ADDENDUM NO. 1

DATE OF ISSUE: October 22,2026
DATE OF ADVERTISEMENT: October 22,2026
DATE OF BID OPENING: October 28,2026

PROJECT NO.: 260018 –Sandoz Elementary Playground Replacement

DEMOLITION PLAN

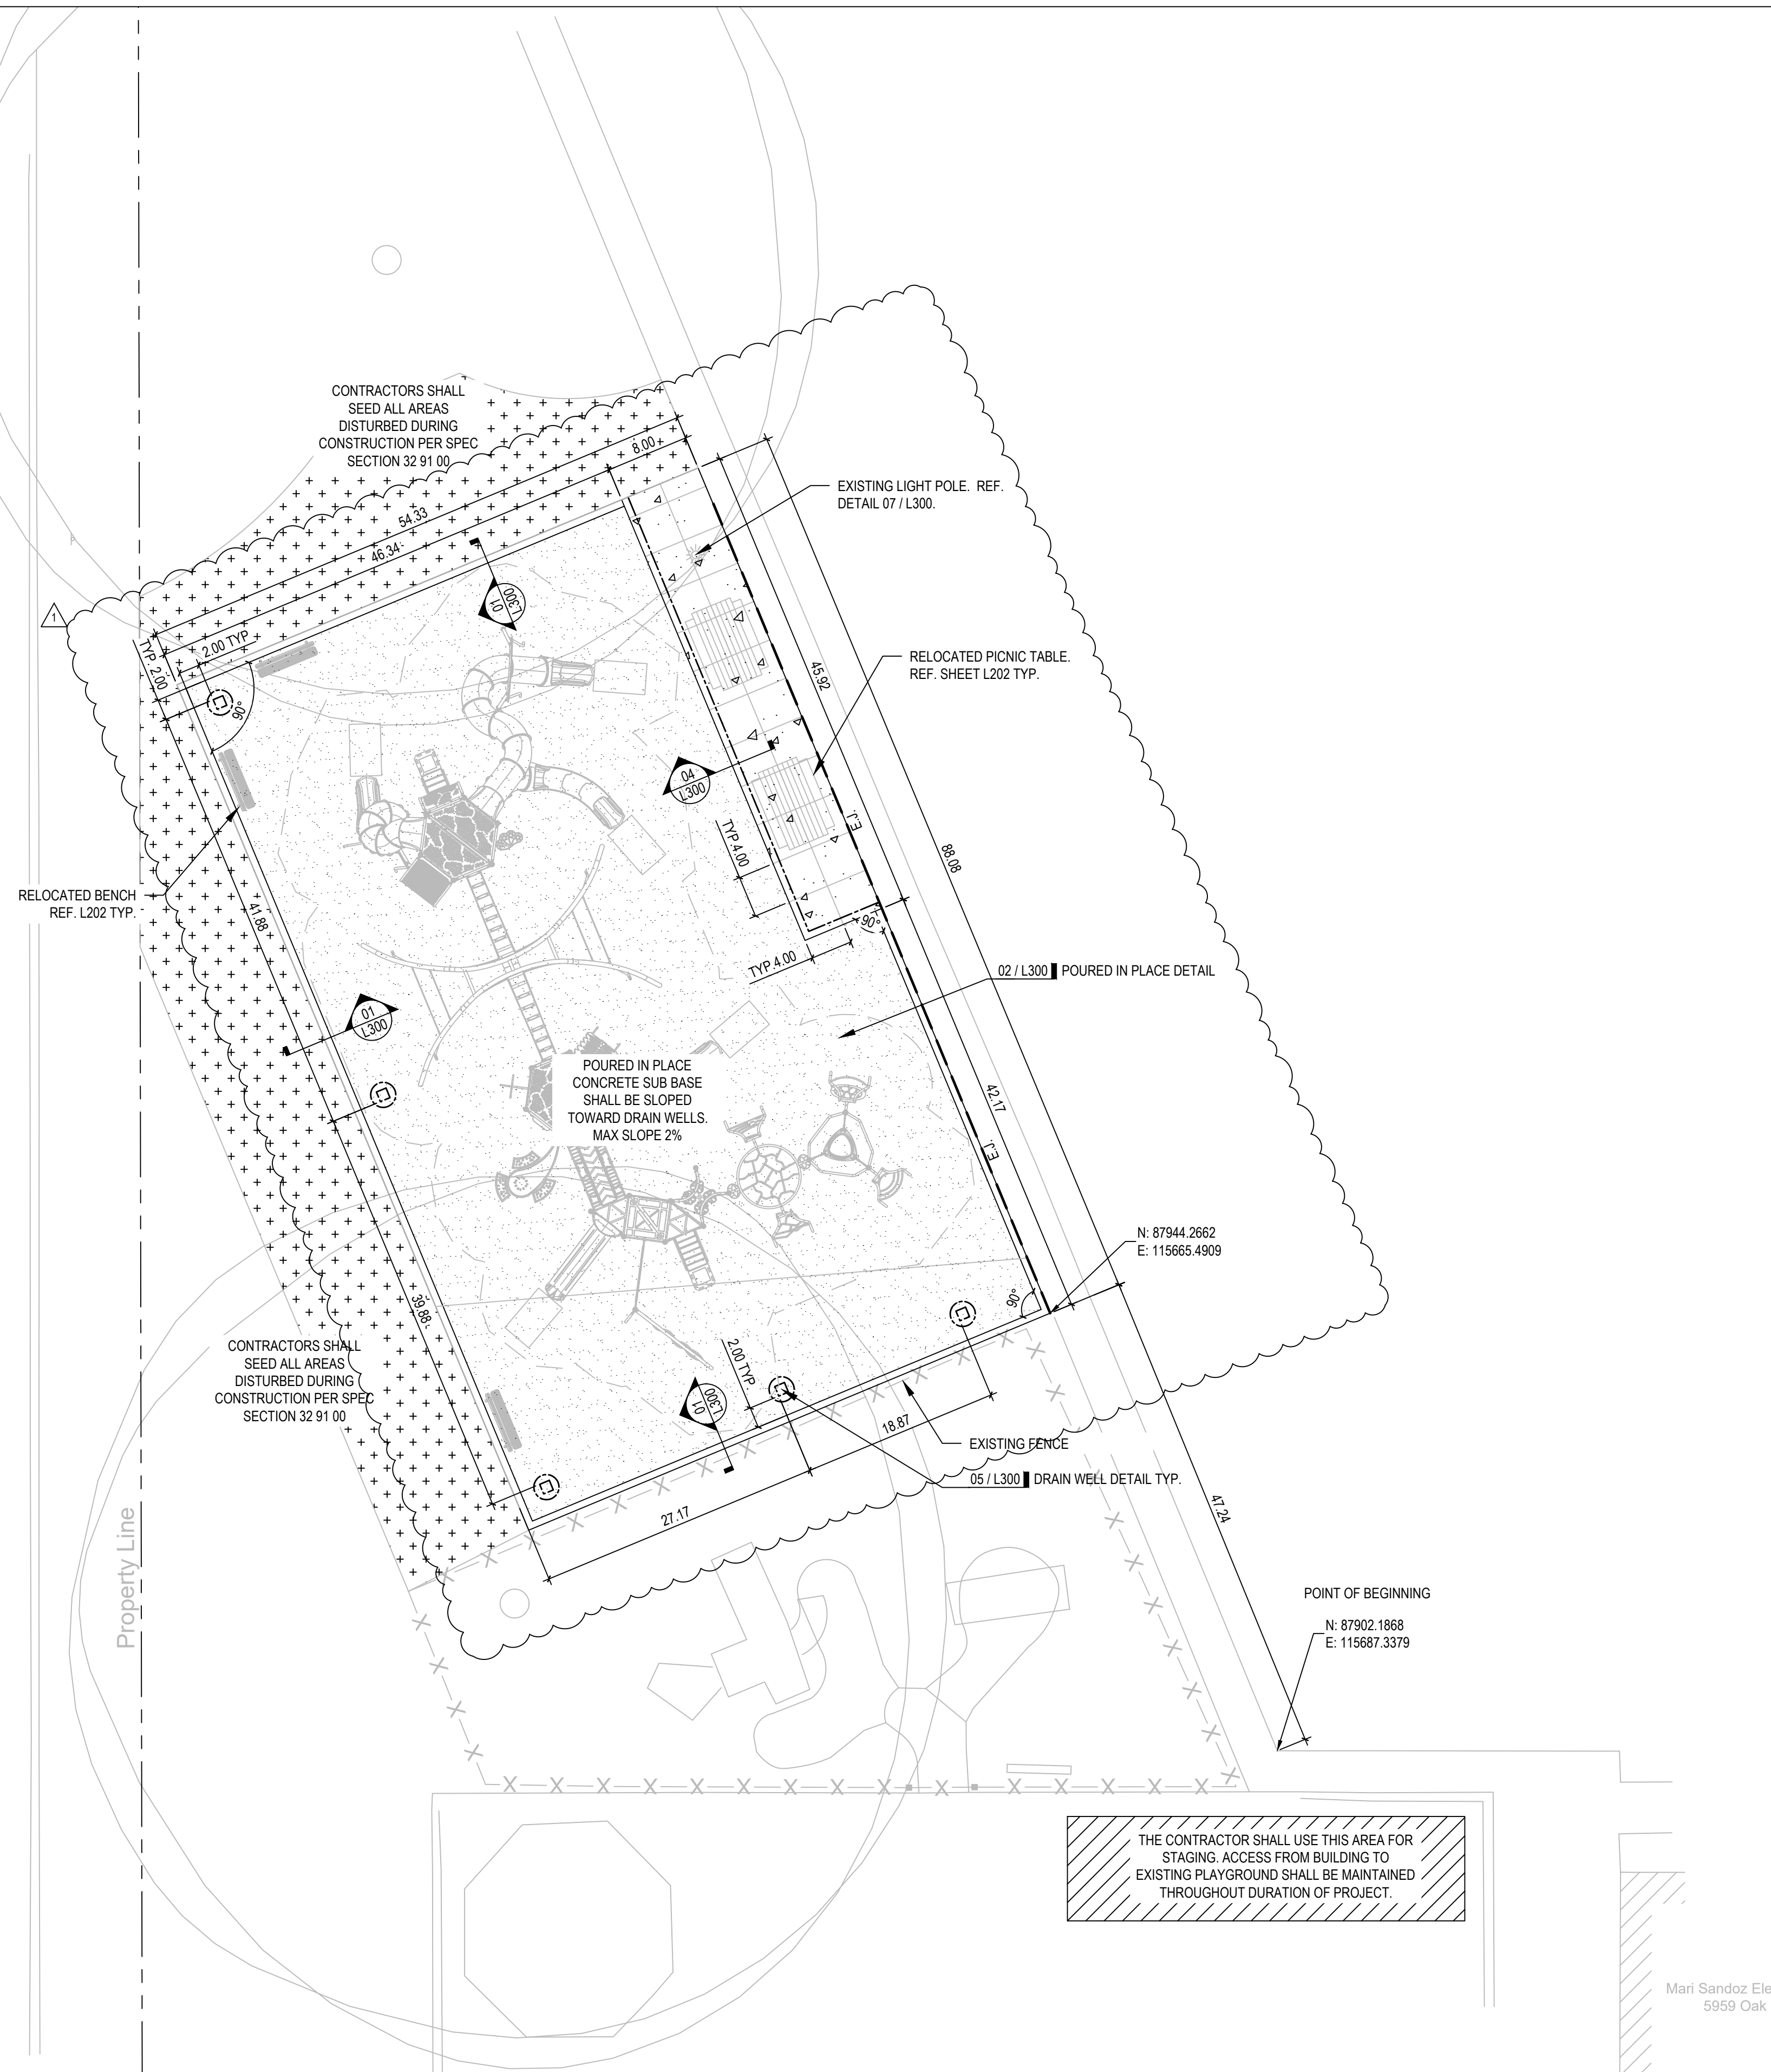
- I. CONSTRUCTION DOCUMENTS – DEMOLITION PLAN – L100**
 1. UPDATE EXTENTS OF TURF REMOVAL NORTH.
 2. REMOVE “EXISTING PLAY EQUIPMENT REMOVAL” FROM DEMOLITION LEGEND
- II. CONSTRUCTION DOCUMENTS – SITE LAYOUT PLAN – L200**
 1. UPDATE OVERALL LAYOUT NORTH.
- III. CONSTRUCTION DOCUMENTS – EQUIPMENT LAYOUT PLAN – L202**
 1. UPDATE EQUIPMENT, BENCHS AND TABLES LAYOUT
 2. UPDATE EQUIPMENT SCHEDULE WITH NEW PLAY EQUIPMENT MODEL NUMBER.
- IV. CONSTRUCTION DOCUMENTS – SITE GRADING PLAN – L300**
 1. UPDATE SPOT ELEVATIONS ALONG NORTH,
 2. RELOCATE SWALE NORTH.
- V. PROJECT MANUAL – BID FORM**
 1. REMOVE AND REPLACE PREVIOUS WITH NEW CONTAINING “1.5 ACKNOWLEDGEMENT OF ADDENEDA”.
